# Thorndon Connections cycleway audit – safety and accessibility

30% design audit

This CASA is for the 90% design stage of the Thorndon Connections (formerly known as “Molesworth-Mulgrave”) routes package, as shown in Figure 1-1.

Figure 4-1: Aitken St driveway

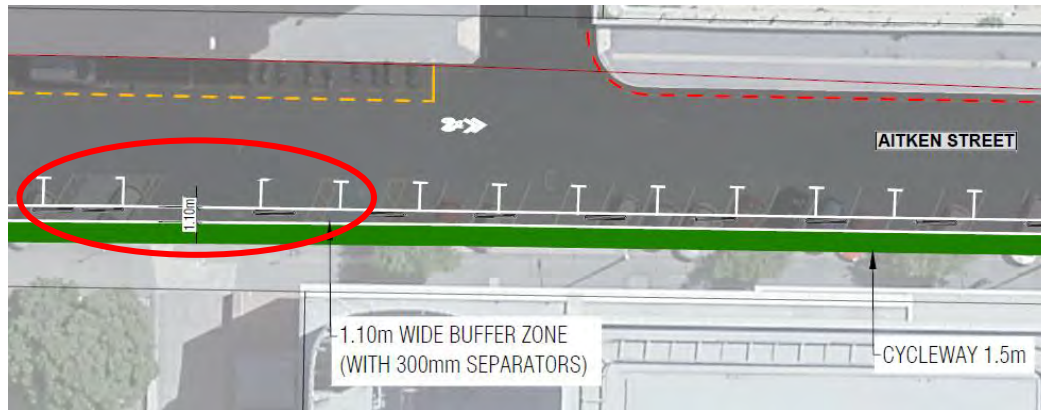
The safety issue is the parallel parking on Aitken St is too close to the driveway (Figure 4-1).

Probability of crash occurring	Likely
Expected crash severity	Minor injury
<b>Primary treatment recommendations:</b>	
4.3.1	Increase parking setbacks to driveway to comply with CNG <a href="#">Technical Note on separated cycleways at side roads and driveways</a>
<b>Supporting treatment recommendations:</b>

The crash type expected is conflict between a motor vehicle entering the driveway and a cyclist on the cycleway, due to the driver’s view of the cyclist being blocked by parked cars. The risk factors are the high parking occupancy along Aitken St and the assumedly high turning volumes into the driveways.

Figure 4-3: Areas of mixing lane where merging is allowed vs excluded, based on vehicle tracking

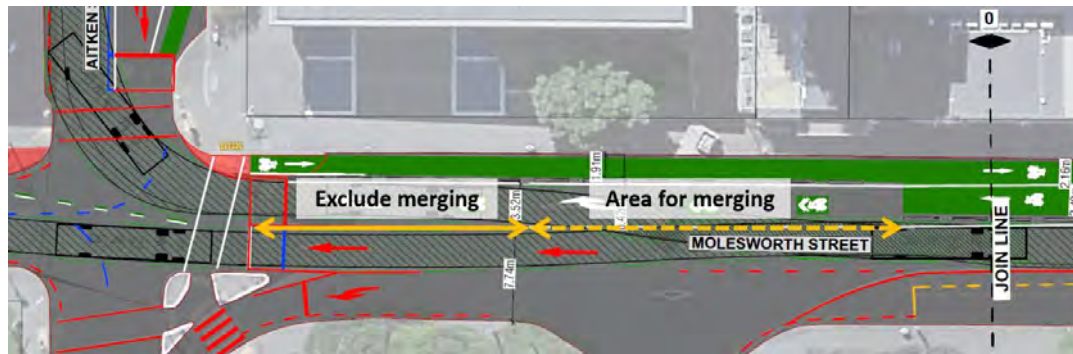
4.6.1	Restrict the merge area of the mixing lanes to lower vehicle entry speeds (see Figure 4-3). E.g. introduce a buffer between the mixing lane and adjacent through-lane and add a line of flexi-posts extending from the limit line.
-------	--

There is currently little available NZ guidance on the design of mixing lanes, however ViaStrada are currently working on a technical note for Waka Kotahi on the subject. It is expected that cyclist volumes will be high in these locations, as are traffic volumes; given also that mixing lanes are not common in Wellington, the probability of a crash occurring is likely. Given that motor vehicles are expected to be travelling around 30 km/h, crashes that do occur would likely result in serious injury.

<b>Designer</b>	<ul style="list-style-type: none"> <li>Restricting merge area at Riddiford St/ Mein St was trialled for the Newtown Cycleway which was not well received by the public. As a result no change to merge length at Murphy St/ Tinakori Rd/ Park St is proposed, as noted above at Aitken St/ Hill St/ Molesworth St, the shared left turn lane will be replaced with a separated cycleway.</li> </ul>
<b>Safety Engineer</b>	<p>Agree with Designer’s response.</p> <p>Merging behaviour at this location should be included in the Monitoring Plan.</p>
<b>Proposed action</b>	<p>Designer to update in 90% designs</p>
<b>Client decision</b>	<p>Accept the proposed action – to include monitoring of merging as part of the monitoring plan</p>

**Figure 4-4: cycleway transition to mixed traffic between bus stop and pedestrian crossing**

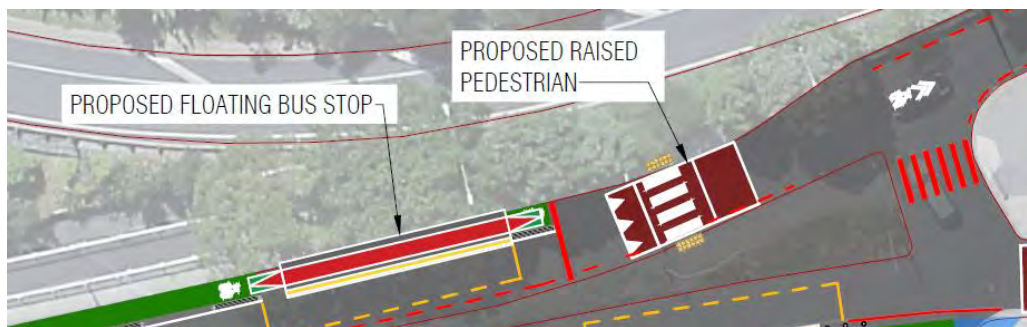
The safety issue is southbound cyclists on Murphy St transitioning from the cycleway to mixed traffic immediately after the floating bus stop (see issue 4.7) and immediately before the new raised pedestrian crossing.

The crash type expected is conflict between a cyclist and a motor vehicle. The risk factors include the proximity of the three conflict points, which increases the cognitive load on drivers and cyclists, the lack of sharrows at the merge location (it is not possible to provide these due to the bus stop and the pedestrian crossing) and the potential for drivers to be distracted looking for pedestrians at the crossing rather than cyclists at the merge point. There are no specific standards relating to this issue. Best practice would be sharrows at and just prior to the merge location, but it is not possible to provide these due to the bus stop and the pedestrian crossing. It is anticipated that cyclists will keep left approaching and crossing the pedestrian crossing, so crashes will be unlikely. The raised platform on the pedestrian crossing will slow motor vehicles, so crashes that do occur should only result in minor injury.

Probability of crash occurring	Unlikely
Expected crash severity	Minor injury
<b>Primary treatment recommendations:</b>	
4.8.1	Shift the bus stop northwards, so a merge can be established prior to the pedestrian crossing (this may also help addressing issue 4.7).
4.8.2	OR continue the cycleway past the pedestrian crossing and merge downstream.
<b>Supporting treatment recommendations:</b>	
4.8.3	As well as providing sharrows at the merge location, provide sharrows just prior to the merge, to alert drivers.
4.8.4	Put sharrows in green boxes, to emphasise the merge to mixed traffic.

<b>Designer</b>	Agree, stop box to be shifted further north and add sharrow at merge location (the location of the stop box will be limited by the need to retain the current shelter in its location).
-----------------	---

**Figure 4-6: void space on Aitken St approach**

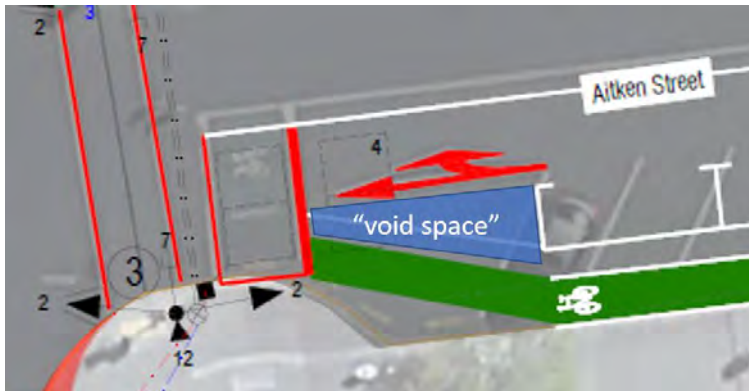
The plans indicate “right-turning cyclists from Aitken St and Hill St to filter right turn”; however, there is little space in the intersection for right-turning cyclists to wait free from the path of parallel and opposing through motor vehicles.

The risk factors for the Hill St approach include the lack of right-turning vehicles from this approach (since Molesworth St is one-way) and therefore no waiting right-turners in the intersection to “shelter” cyclists. Also, parallel through-traffic will likely err towards the right side of the lane, due to the bus stop on the departure side.

The risk factors for the Aitken St approach include right-turning cyclists having to get past the parallel through-traffic, as they are originating from a kerbside cycle lane. This is complicated by the taper on the cycle lane after the termination of the parking – drivers may use the “void space” (see Figure 4-6) to form two queues. Also, right-turning cyclists will want to wait a shorter distance into the intersection than right-turning drivers, because the cycle lane on Molesworth St is on the right-hand side.

| 4.17.2 | Offset the Aitken St and Hill St approach lanes and provide a pocket right-turn cycle lane with advanced stop line on Hill St.  |

<ul style="list-style-type: none"> <li>Demand for right turn from Hill Street is expected to be very low as vehicles on Tinakori Road from the north or south can use either Mulgrave Street or Bowen Street respectively to access the Bunny Street / Lambton Quay area. Furthermore, any provision would need a separate phasing creating LOS issues for bikes and buses and would potentially create confusion for other vehicles.</li> </ul>
<b>Safety Engineer</b>	Agree with Designer's response.  Cycle right turn demand from Hill Street to be monitored, and further mitigation if necessary.
<b>Proposed action</b>	Monitor right turn demand as proposed above. Conduct cyclist count
<b>Client decision</b>	Accepted

Figure 5-1: Lane markings at 61 Molesworth area

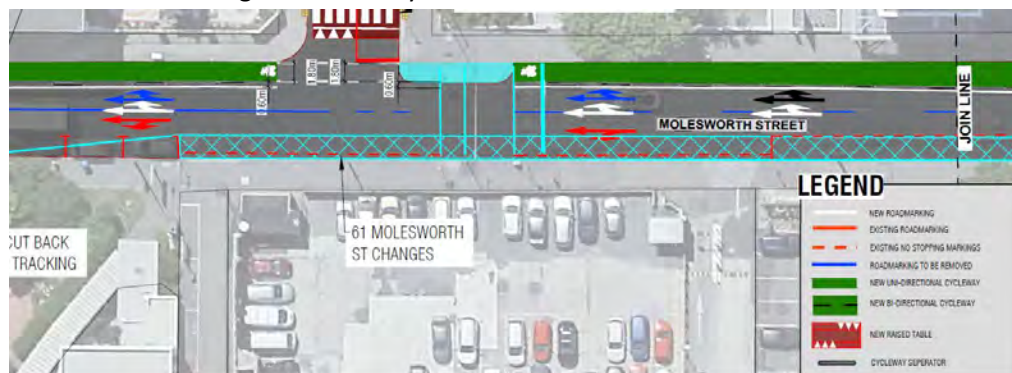
The design colour coding suggests existing shared through / left-turn lane to be retained, and through / right-turn lane to be shifted over, however this does not properly reflect the intention of there being one lane only in this section.

5.4.1 Modify the lane arrows to show there is only one lane in this section.

<b>Designer</b>	<ul style="list-style-type: none"> <li>Agree to rationalise in 90% designs</li> </ul>
<b>Safety Engineer</b>	Agree with CAT and Designer’s response.
<b>Proposed action</b>	Designers to update in 90% designs.

Figure 4-2: cycleway transition in vicinity of bus stop and pedestrian crossing

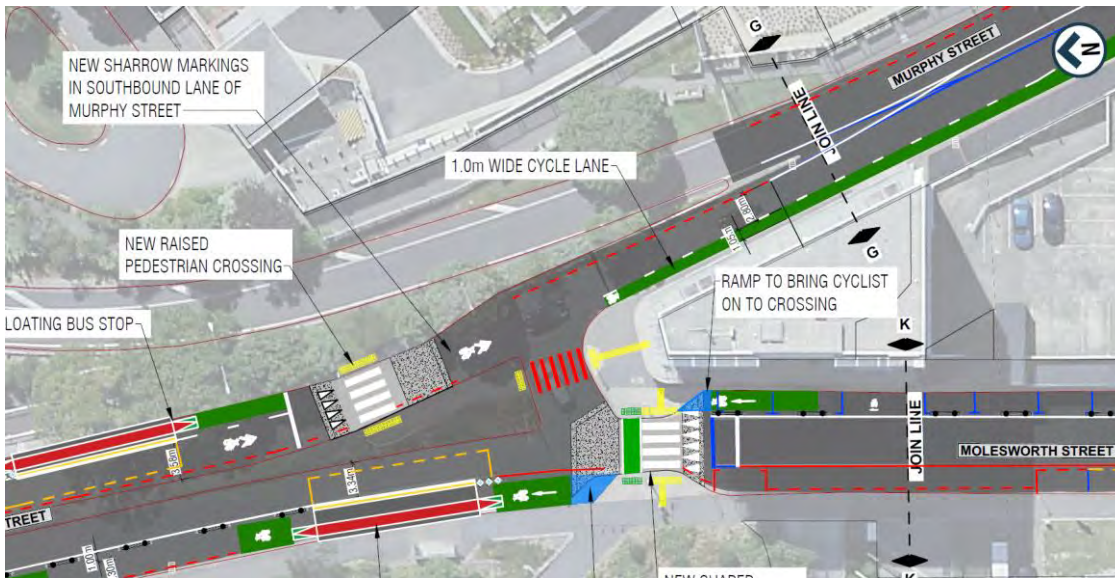
This location was covered in item 4.8 of the 30% CASA; the recommendations have been largely addressed, but some changes have resulted in new issues to consider.

The safety issue is that the merge point for cyclists and motorists appears to be on the pedestrian crossing platform; this could cause confusion for cyclists or motorists and could ultimately result in motorists failing to merge correctly with cyclists or give way to pedestrians on the crossing.

Firstly, shifting the bus stop back has improved the distance available for cyclists and motorists to merge.

<b>Designer</b>	Agree with the CAT, to amend design of merge
<b>Safety Engineer</b>	Agree with CAT and Designer.
<b>Proposed action</b>	Update plans
<b>Client decision</b>	Agree with Proposed Action

Figure 4-3: narrow cycle lane on Murphy Street

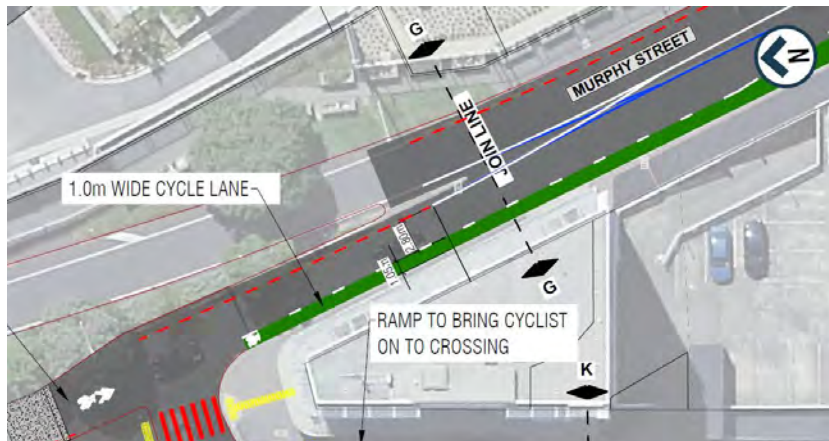
The safety issue is the cycle lane on Murphy Street after the pedestrian crossing (see Figure 4-3) is too narrow.

The crash type expected is cyclist vs motorist.

Figure 4-4: Mixing lane with defined merging length

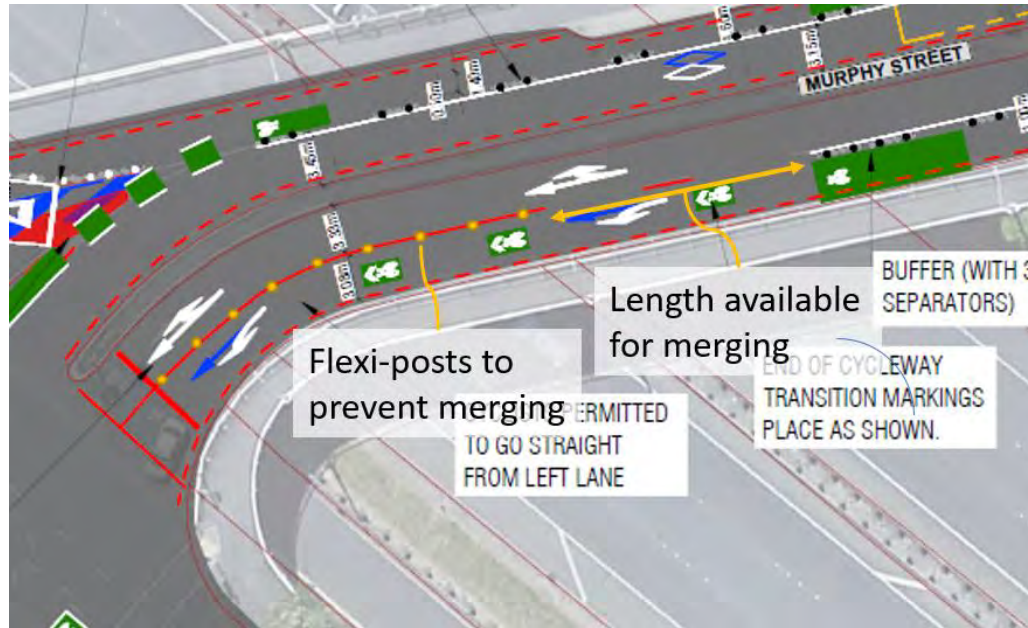
4.4.1	Restrict the merge area of the mixing lanes e.g. by adding flexi-posts along (at least some of) the lane line from the limit line. The extent should be based on vehicle tracking to enter the mixing lane, and vehicle tracking within the lane should also be considered. Figure 4-4 illustrates the concept.
-------	---

<b>Responses:</b>	
<b>Designer</b>	Agree with CAT, to restrict length available for merging
<b>Safety Engineer</b>	Agree with CAT and Designer.
<b>Proposed action</b>	Update plans
<b>Client decision</b>	Agree with Proposed Action
<b>Action taken</b>	Plans updated

**Figure 4-5: Likely cyclist non-compliant manoeuvres and resulting conflicts**

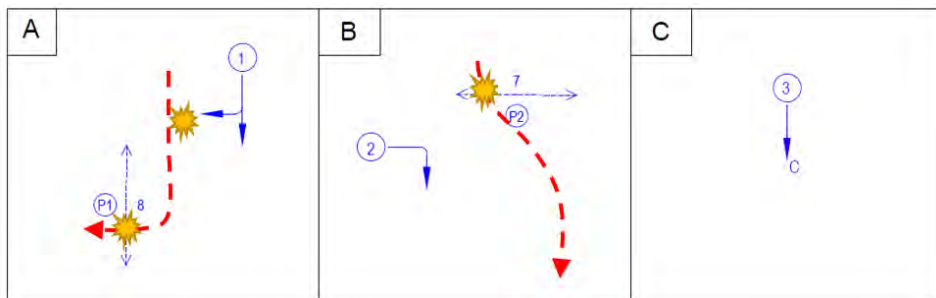
There are two cycle movements coming from the Mulgrave Street cycleway at this location – the diagonal crossing towards the left, assumedly the main cycle movement, plus the right turn into Aitken Street. Whilst one of the two cycle movements could be accommodated in either the A phase (Mulgrave traffic), and the other in the B phase (right turn from Aitken St) it would not be possible to accommodate both cycle movements, therefore a separate cycle phase has been added.

The problem is that, in either the A or B phase, there will be cyclists waiting at the limit line believing that they could progress safely, and some cyclists will choose to run a red light to improve their efficiency – these are illustrated in Figure 4-5. In the B phase, cyclists travelling along Mulgrave Street would be safe to cross on a sharp diagonal, provided they do not conflict with any pedestrians crossing Mulgrave Street. In the A phase, cyclists turning right might do so, but they would risk conflict with any pedestrians crossing Aitken Street and, of greater concern, they would be at risk of being hit by vehicles turning right into Aitken Street.

Furthermore, whilst one cyclist may be able to judge a safe manoeuvre, subsequent cyclists may follow along without adequately judging the situation. For example, a confident right turning cyclist may move in the B phase, knowing they can make it before an approaching right turning vehicle, but the cyclist behind them may not notice the vehicle or judge the

**Figure 4-6: Existing illegal manoeuvre from Kate Sheppard Place eastern end**

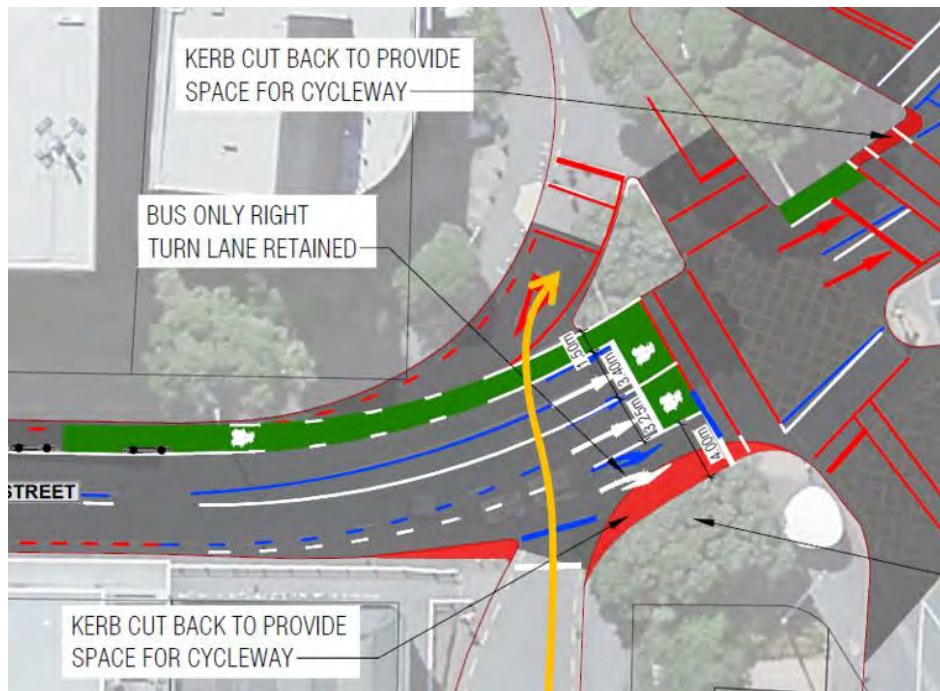
4.7.3	Consider physical devices that make the illegal movement more difficult, e.g. flexiposts on the edge of the cycle lane.
-------	---

presence of contra-flow cyclists, plus the complication that these cyclists will be travelling fast in the downhill direction. Moreover, the CAT was informed that it was decided to retain the two-way functionality of Kate Sheppard Place at Molesworth Street because making it one-way would exacerbate the existing problem of drivers disregarding the right turn-only restriction at the other end of Kate Sheppard Place and crossing three lanes of traffic to access the left turn from Mulgrave Street to Thorndon Quay.

The CAT acknowledges that adding the cycle lane would worsen the consequences of this existing illegal manoeuvre, as drivers then have an additional lane to cross and cyclists are more vulnerable than motorists. However, we suggest that the risk to the cyclists on Murphy Street would not be as great as the risk to the contraflow cyclists on Molesworth Street, as the Murphy Street cyclists are travelling in the same direction as the general traffic and therefore more likely to be seen the drivers exiting Kate Sheppard Place. Furthermore, it

**Figure 5-1: Different chicane designs on Hill Street**

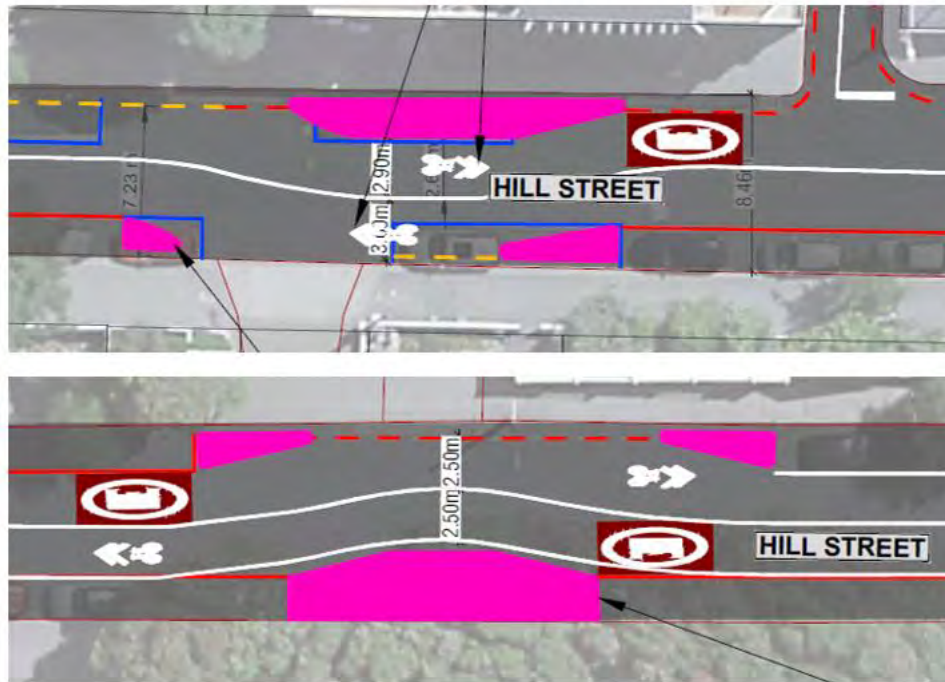
The two chicanes on Hill Street employ different marking layouts regarding the use of the 30 and sharrows markings (Figure 5-1). It would be preferable to have a consistent design.

Probability of crash occurring	N/A
Expected crash severity	N/A
<b>Indicative recommendations:</b>	
5.2.1	Locate the 30 markings at the start of the chicanes (as per the design west of Eccleston Hill) – to ensure drivers approach at a suitable speed.
5.2.2	Locate the sharrows at the mid-point of the chicane (as per the design west of Selwyn Tce) – to remind drivers that cyclists share this street.

Figure 5-2: Gap between limit line and pedestrian crosswalk

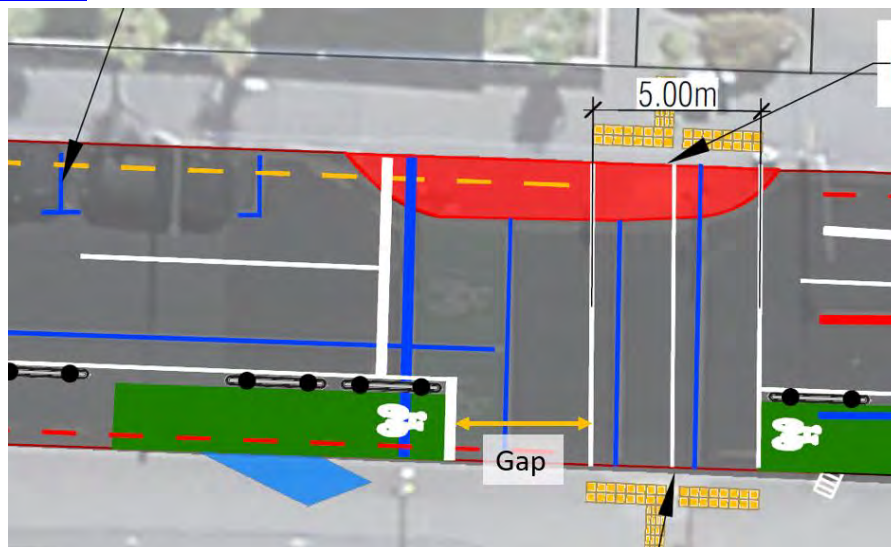
There is a large gap between the advanced stop line and the pedestrian / cycle midblock crossing line; this is only required to be 200mm – see CNG section on [cyclist waiting facilities at intersections](#).

<b>Designer</b>	Agree with CAT, to shift cycle limit line
<b>Safety Engineer</b>	Agree with CAT and Designer.
<b>Proposed action</b>	Update plans
